Final Initial Study/Mitigated Negative Declaration

LS Power Grid California Manning 500/230 Kilovolt Substation Project

June 2025

Project Element Map 17 of 23

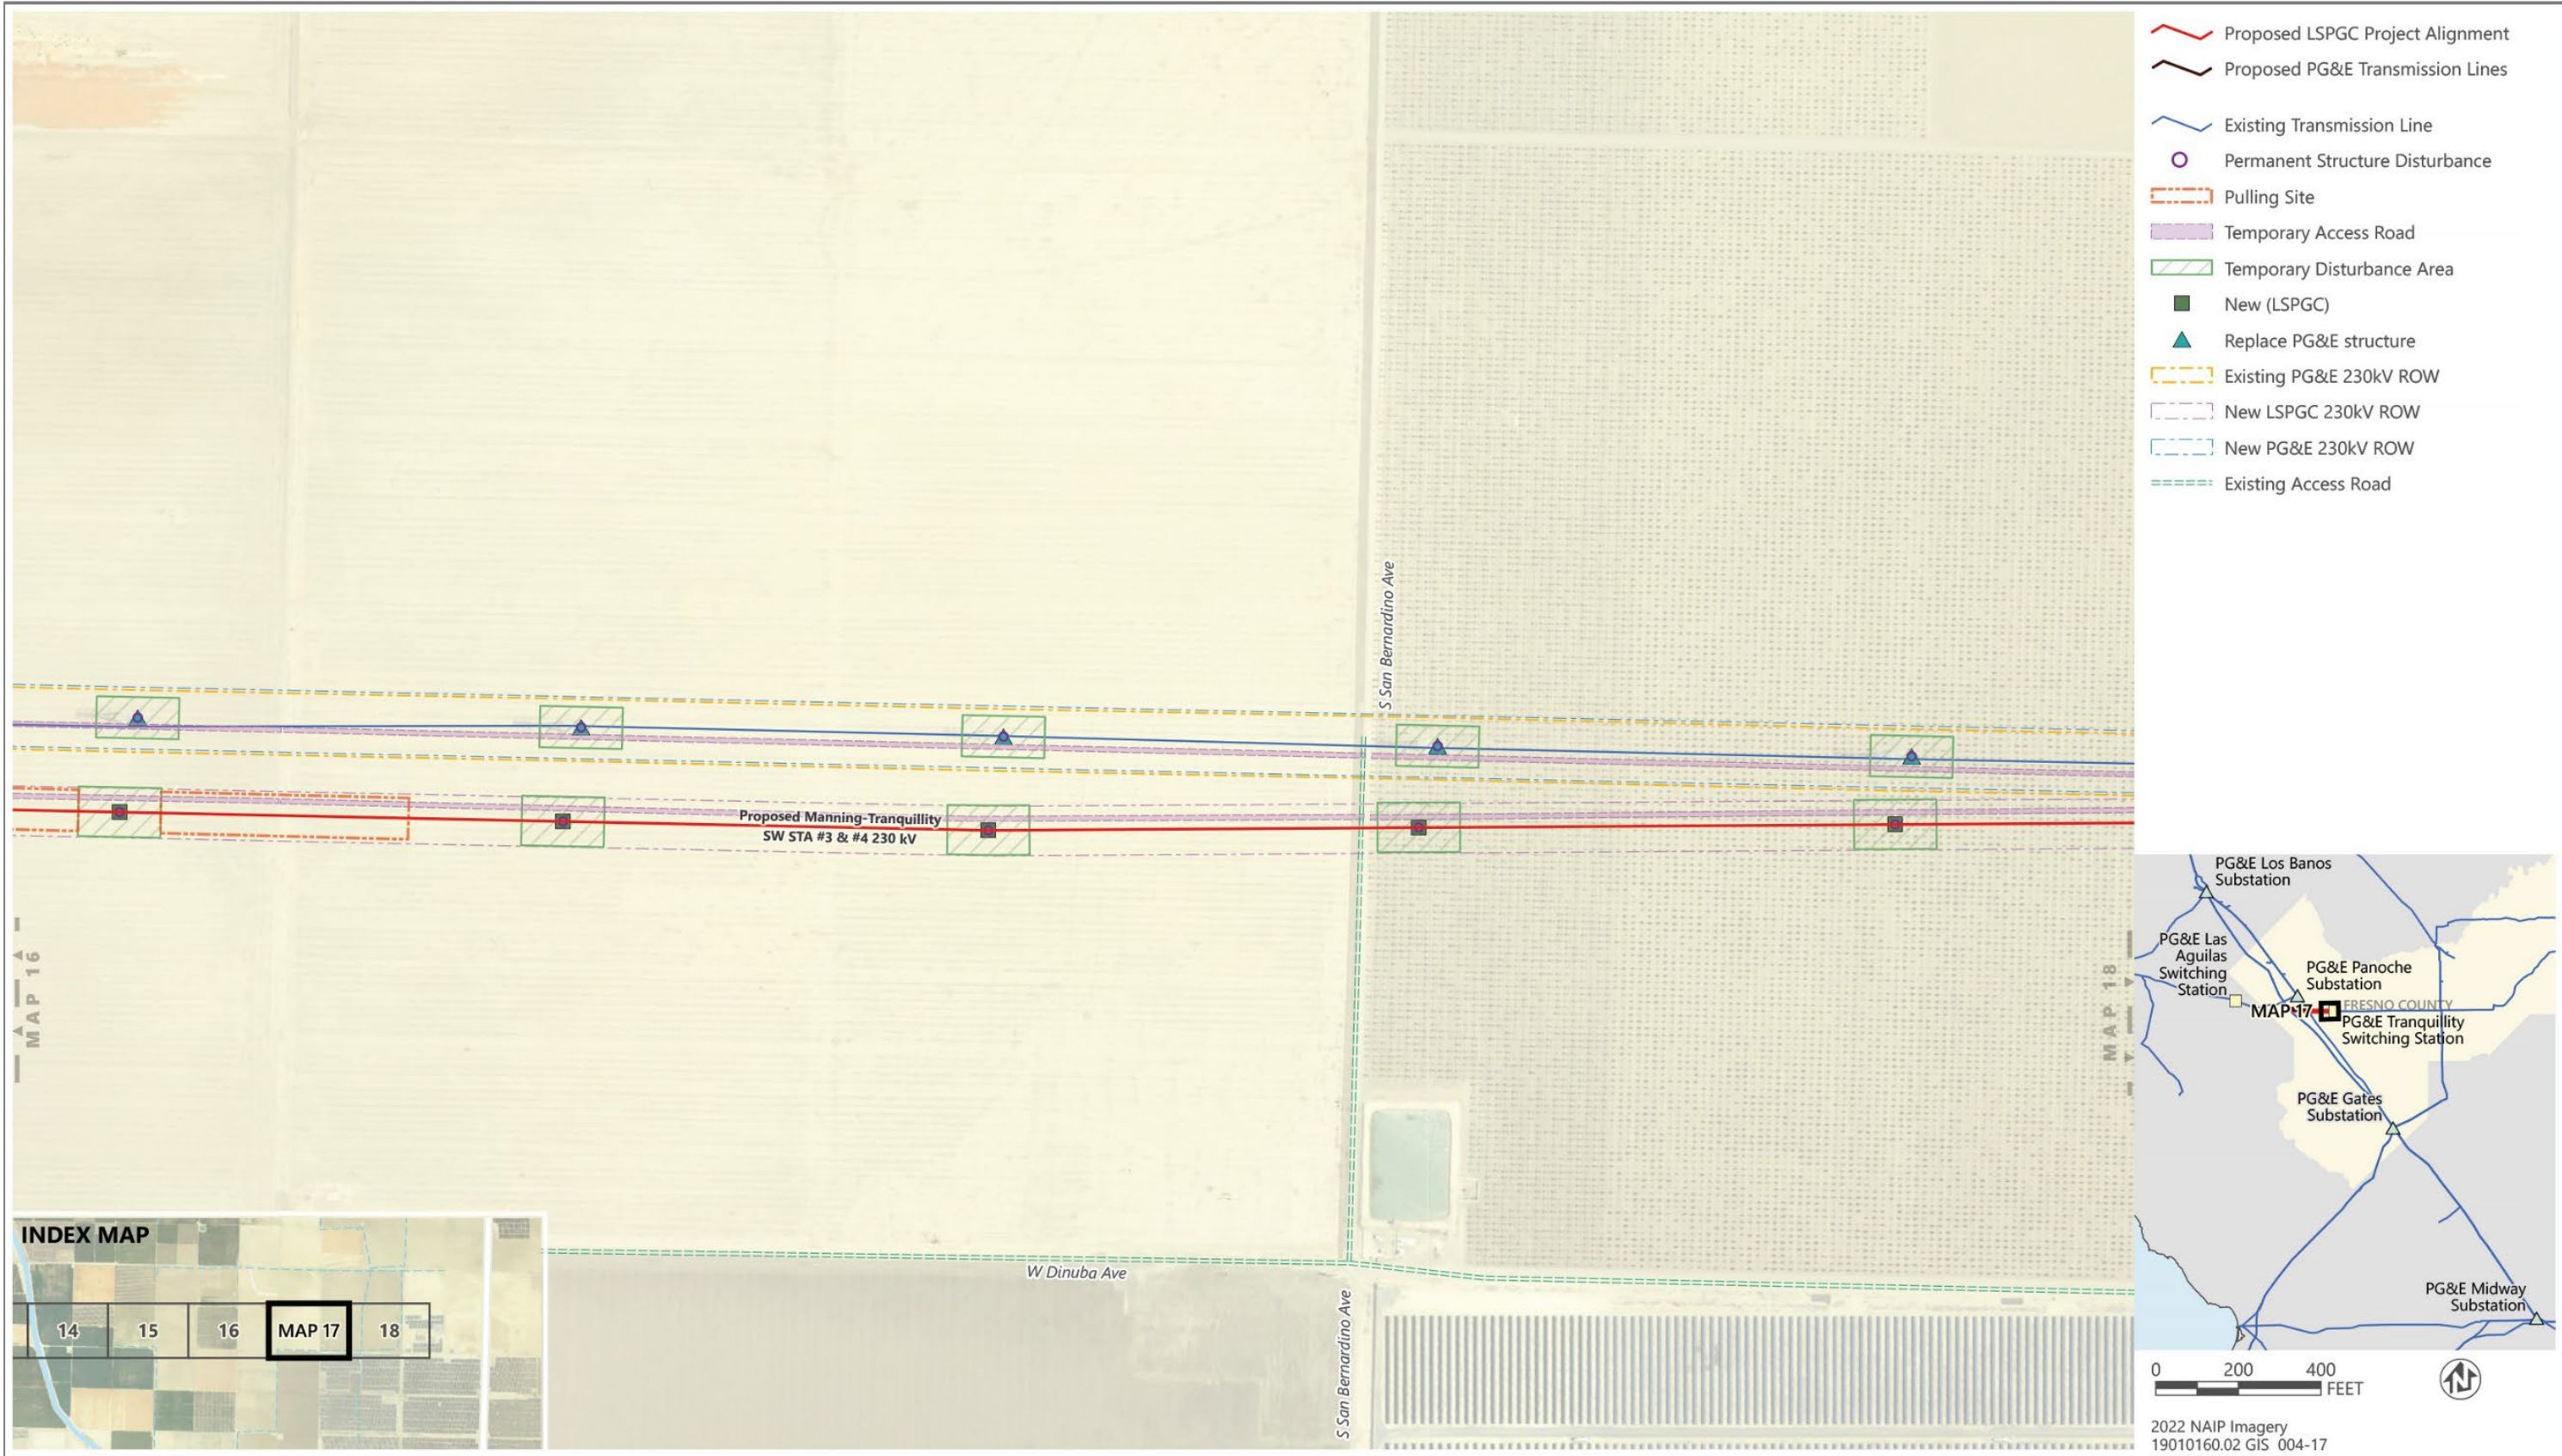
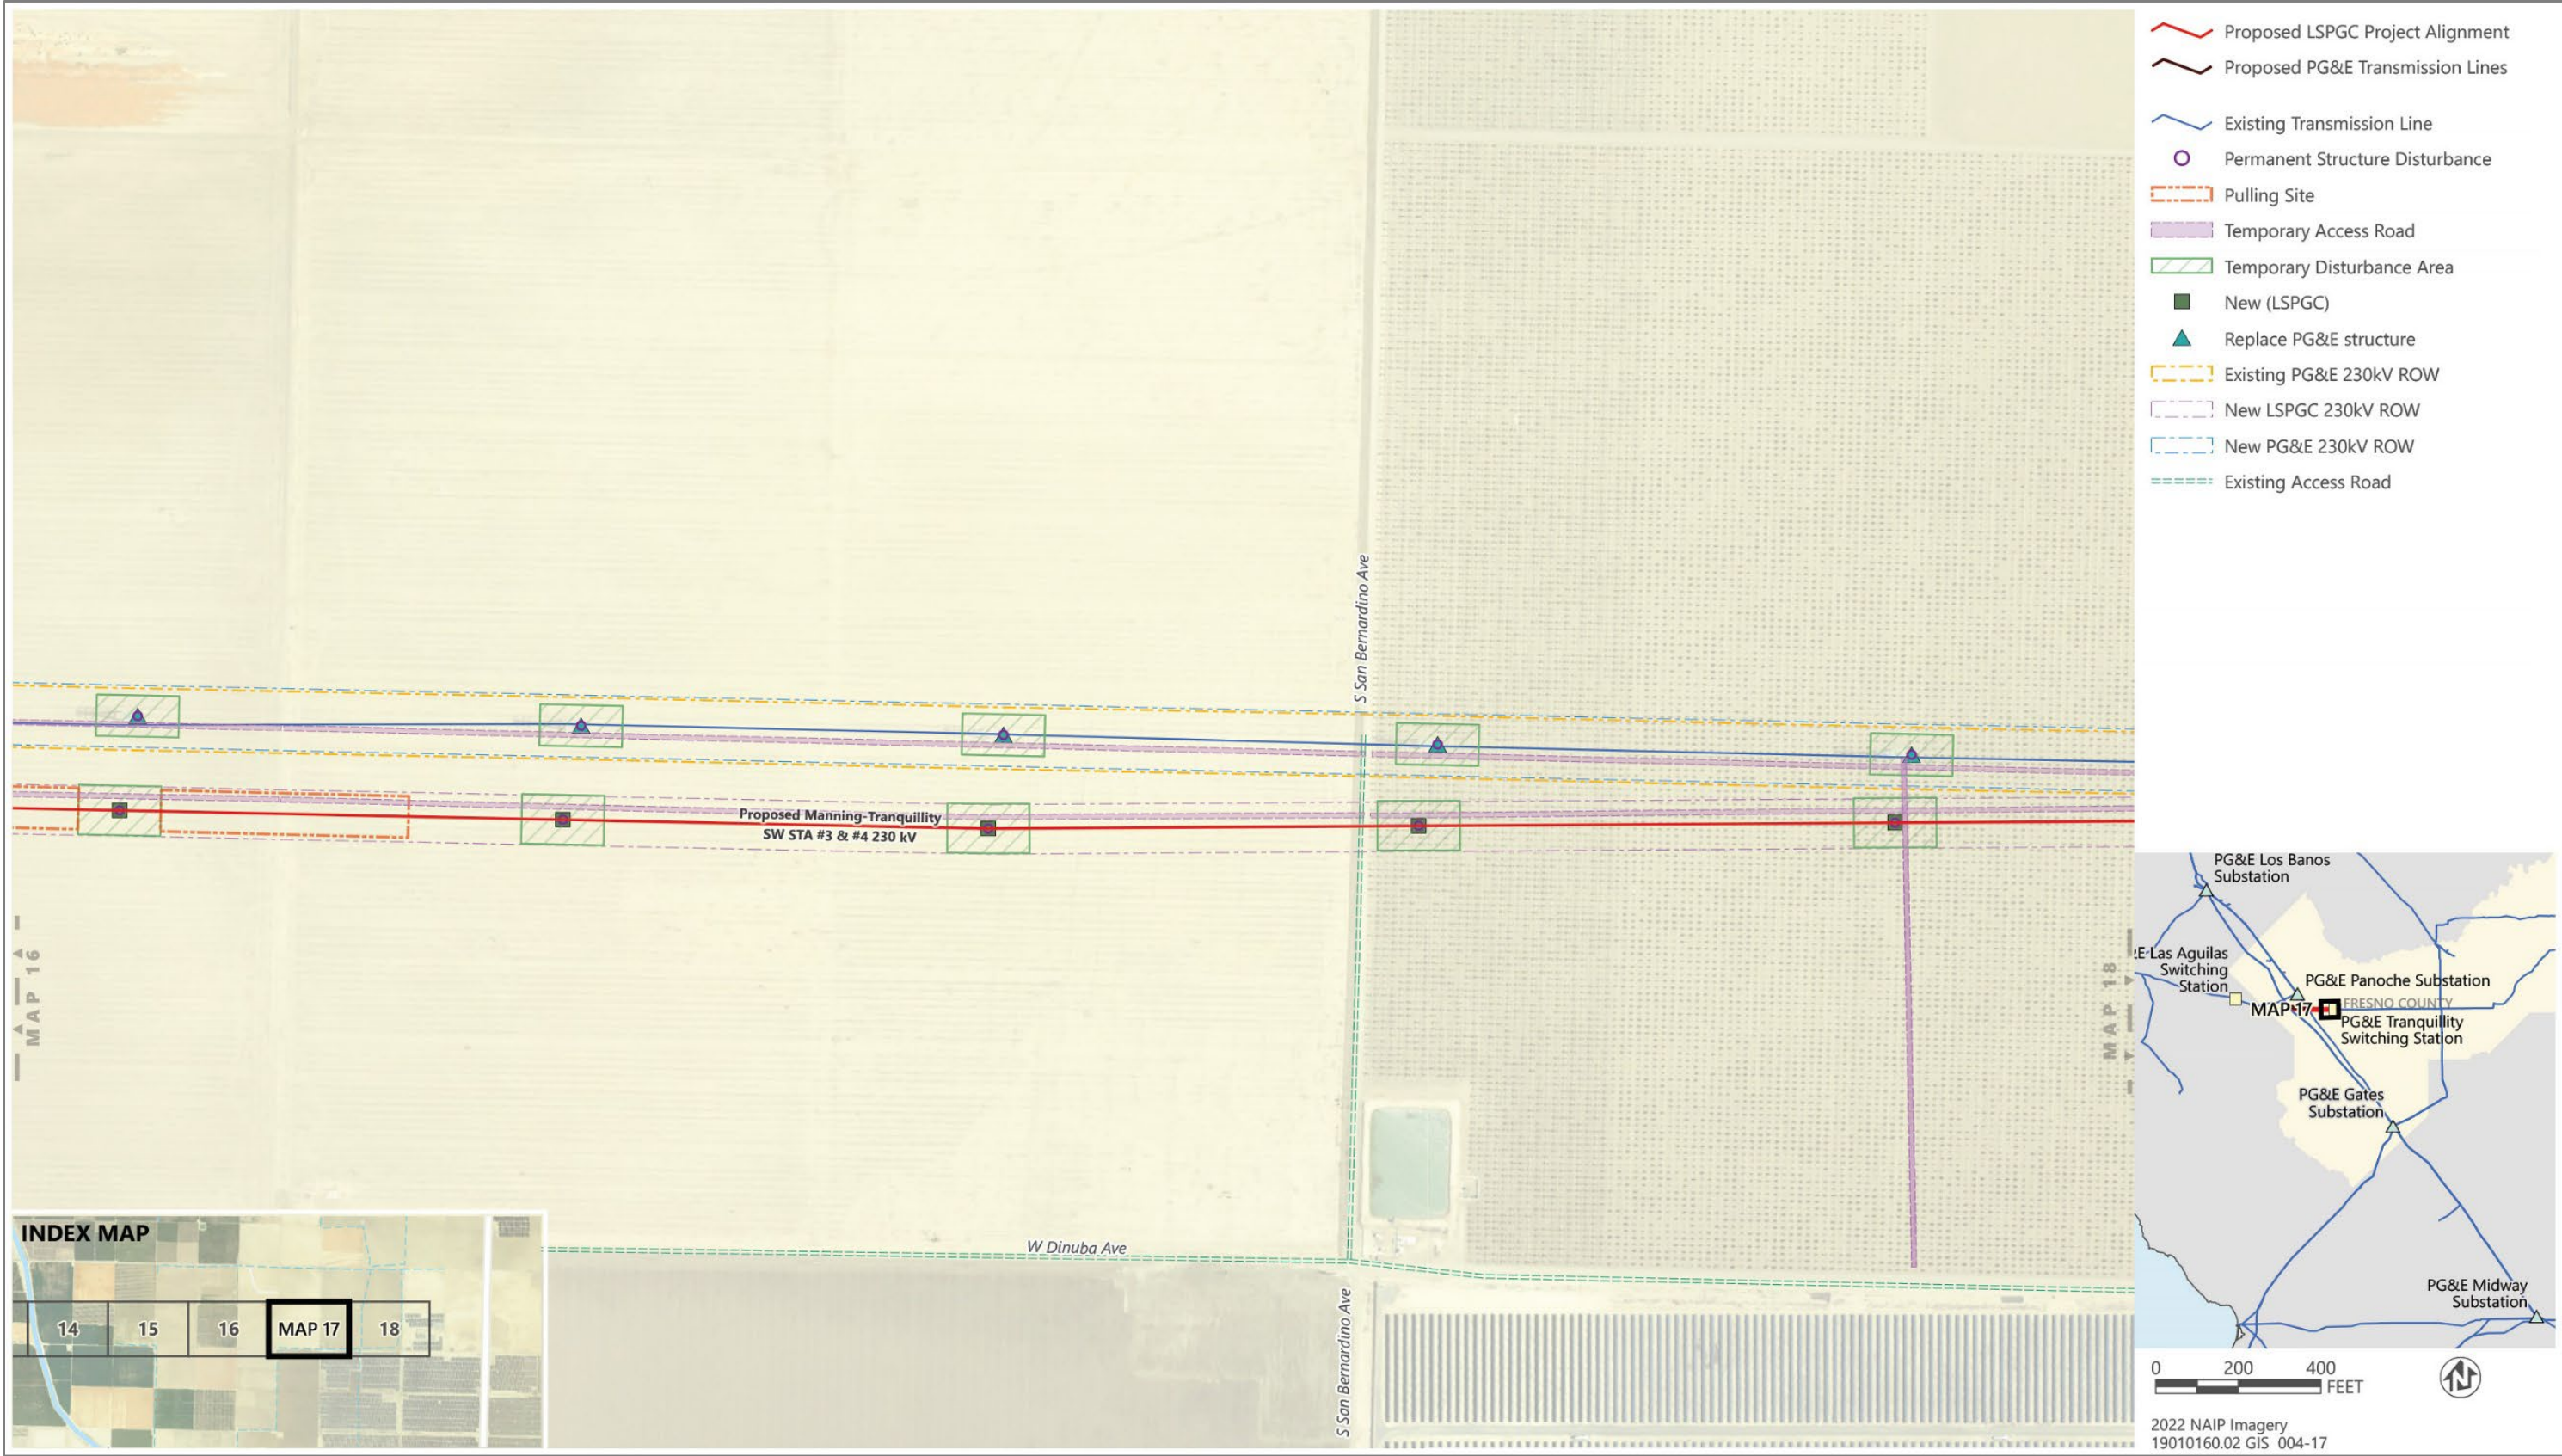
In response to Comment O1-13, revisions have been made to Project Element Map 17 of 23 on page A-17 of the Appendix A to Appendix 1:
